**EXPRESS TERMS
FOR
PROPOSED BUILDING STANDARDS
OF THE
DEPARTMENT OF HOUSING AND COMMUNITY DEVELOPMENT
REGARDING PROPOSED CHANGES TO THE 2007 CALIFORNIA BUILDING CODE (CBC)
CALIFORNIA CODE OF REGULATIONS, TITLE 24, PART 2
(HCD 02/07)**

The Department of Housing and Community Development (HCD) proposes to make necessary changes to the 2007 edition of the California Building Code (CBC), based on the 2006 International Building Code (IBC), as presented on the following pages. HCD further proposes to:

FIGURE 11A-6A—WARNING STRIPING AND HANDRAIL EXTENSIONS

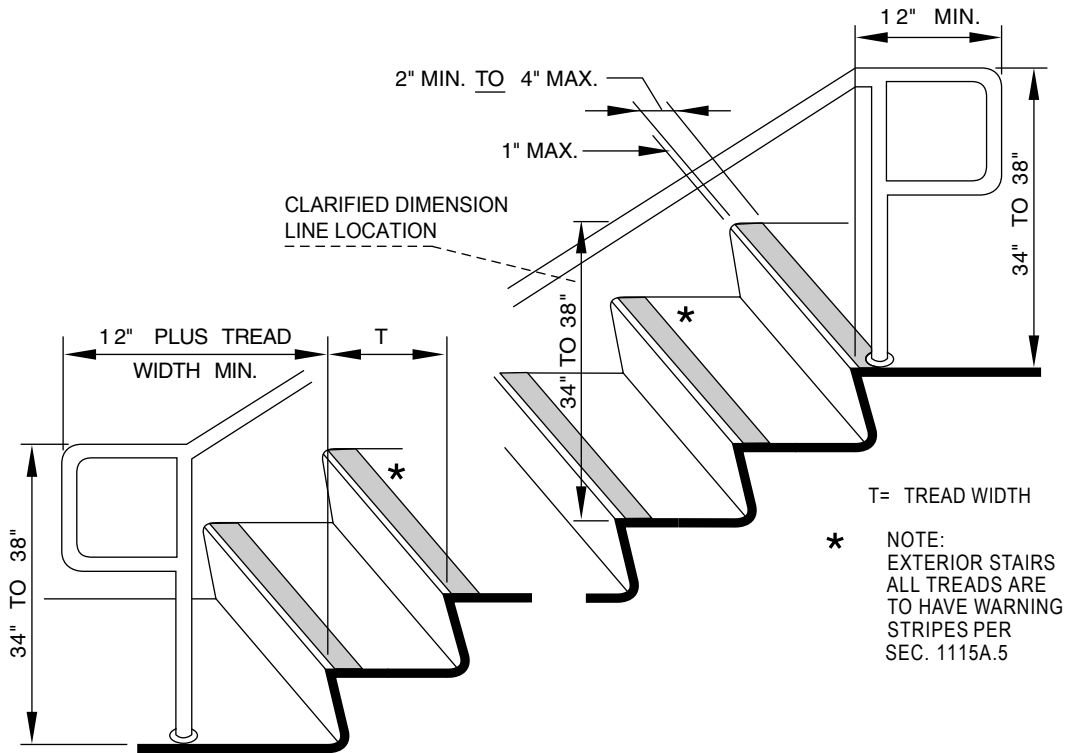
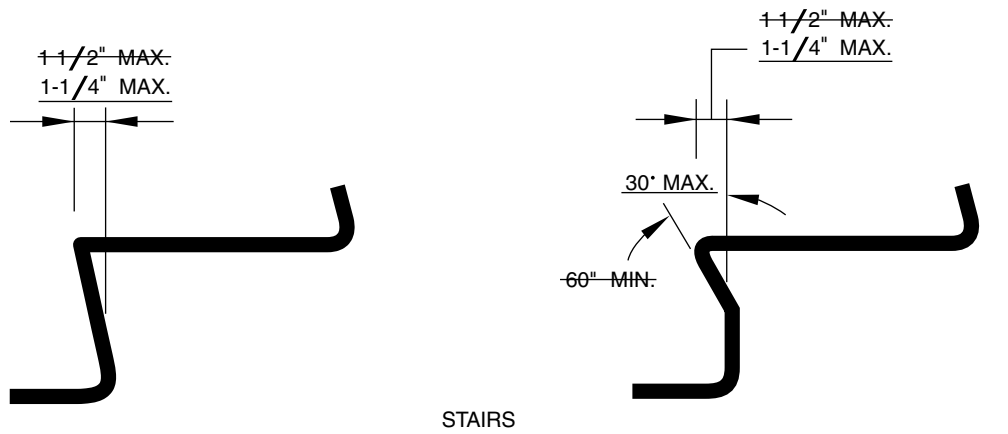
1115A.4 Nosing. Nosing shall not project more than ~~4 ¼~~ 1 ¼ inches (~~38.1~~ 31.8 mm) past the face of the riser below. Risers shall be sloped or the underside of the nosing shall have an angle not ~~less~~ more than ~~60~~ 30 degrees (0.52 rad) from the ~~horizontal~~ vertical. (See Figure 11A-6A).

1123A.4 Nosing. Nosing shall not project more than ~~1½~~ 1¼ inches (~~38.1~~ 31.8 mm) past the face of the riser below. Risers shall be sloped or the underside of the nosing shall have an angle not ~~less more~~ than 60 30 degrees (0.52 rad) from the ~~horizontal~~ vertical. (See Figure 11A-6A)

1123A.6.2.3 Handrail extension. Handrails shall extend a minimum of 12 inches (305 mm) beyond the top nosing and 12 inches (305 mm), plus the tread width, beyond the bottom nosing. Where the extension creates a hazard, the termination of the extension shall be rounded or returned smoothly to floor, wall or post. Where the stairs are continuous from landing to landing, the inner rail shall be continuous and need not extend out into the landing. (See Figures 11A-6A and 11A-6E).

33. Amend Figure 11A-6A “WARNING STRIPING AND HANDRAIL EXTENSIONS”:

FIGURE 11A-8J – PLATFORM AT SECONDARY EXTERIOR DOOR

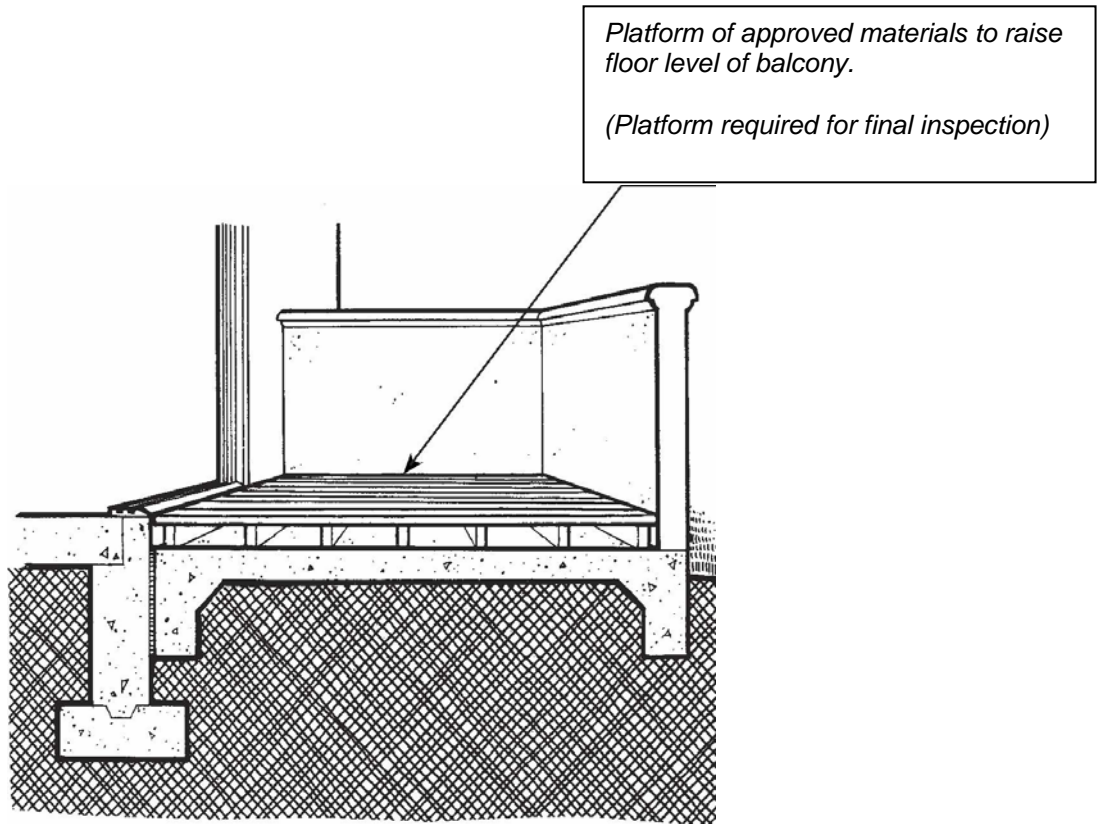
3. Secondary exterior doors onto decks, patios or balcony surfaces constructed of impervious materials (e.g., concrete, brick, flagstone) may have a maximum change in height from the interior landing of 4 inches (101.6 mm). Changes in height greater than ½ inch (12.7 mm) shall be accomplished by means of a ramp complying with Section 1114A or by means of a platform constructed to the level of the floor as illustrated in Figure 11A-8J.

34. Add Figures 11A-8J, 11A-8K, 11A-9L and 11A-9M:

FIGURE 11A-8K – RAMP AT SECONDARY EXTERIOR DOOR

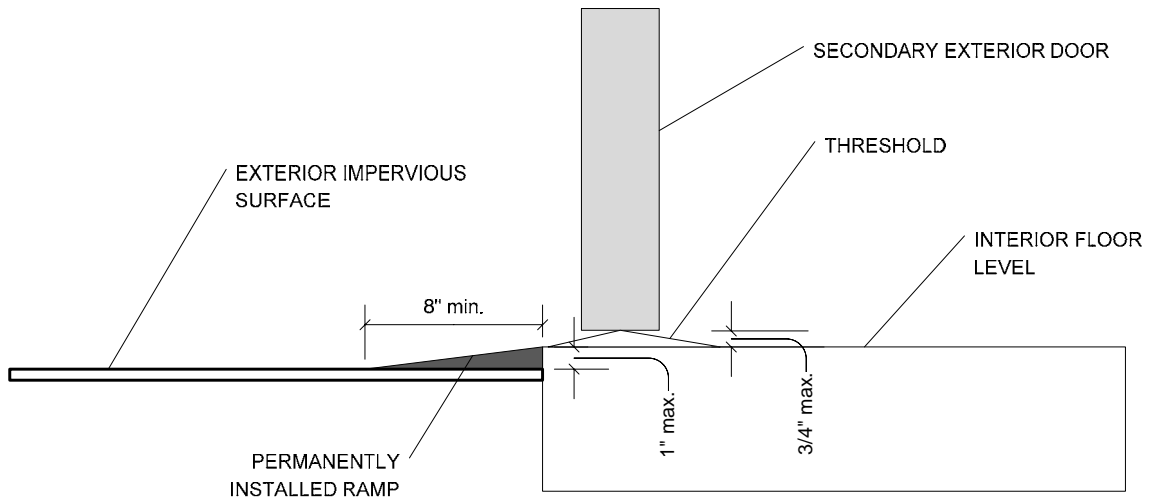
4. Secondary exterior doors onto decks, patios or balcony surfaces constructed of impervious materials (e.g., concrete, brick, flagstone) may have a maximum change in height from the interior landing of 1 inch (25.4 mm), provided a ramp with a maximum slope of 1:8 is permanently installed. (See Figure 11A-8K.)

FIGURE 11A-9L – SHOWER WITH WATER CLOSET

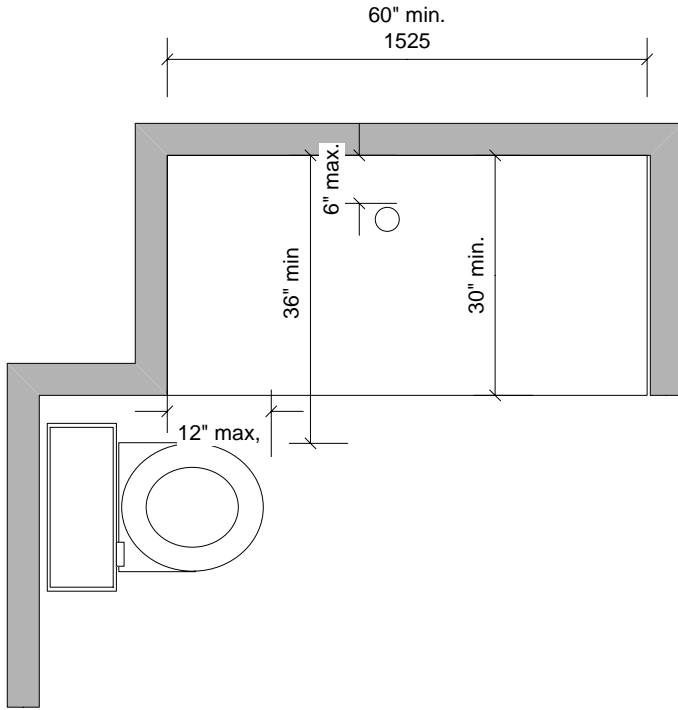
~~1.2 The shower stall shall measure at least 30 inches deep by 60 inches wide (762 mm by 1524 mm) with an entrance opening of at least 60 inches (1524 mm). A water closet may project a maximum of 12 inches (305 mm) into the opening provided that a minimum of 36 inches (914 mm) clear space is maintained between the water closet and the shower wall as illustrated in Figure 11A-9L or;~~

FIGURE 11A-9M – WING WALL OR CABINET AT WATER CLOSET

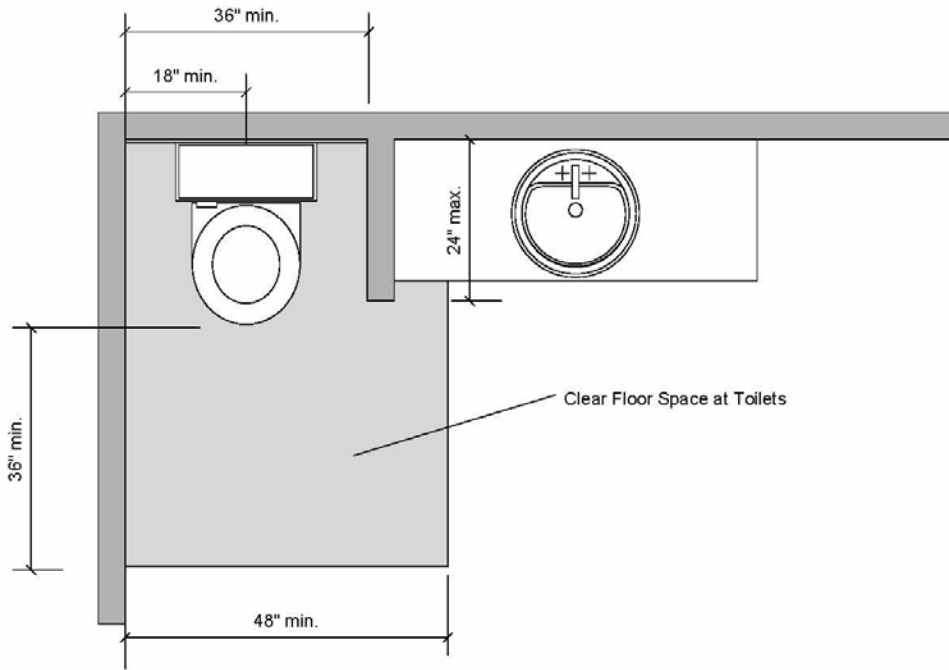
~~1. Floor Space.~~ ~~The water closet shall be located in a space a minimum of 36 inches (914 mm) in clear width with 48 inches (1219 mm) minimum clear space provided in front of the water closet. This space may include maneuverable space under a lavatory, if provided and arranged so as not to impede access. The minimum floor space provided at a water closet shall be 48 inches (1219 mm) in clear width. The clear floor space shall extend past the front edge of the water closet at least 36 inches (914 mm). See Figure 11A-9M.~~
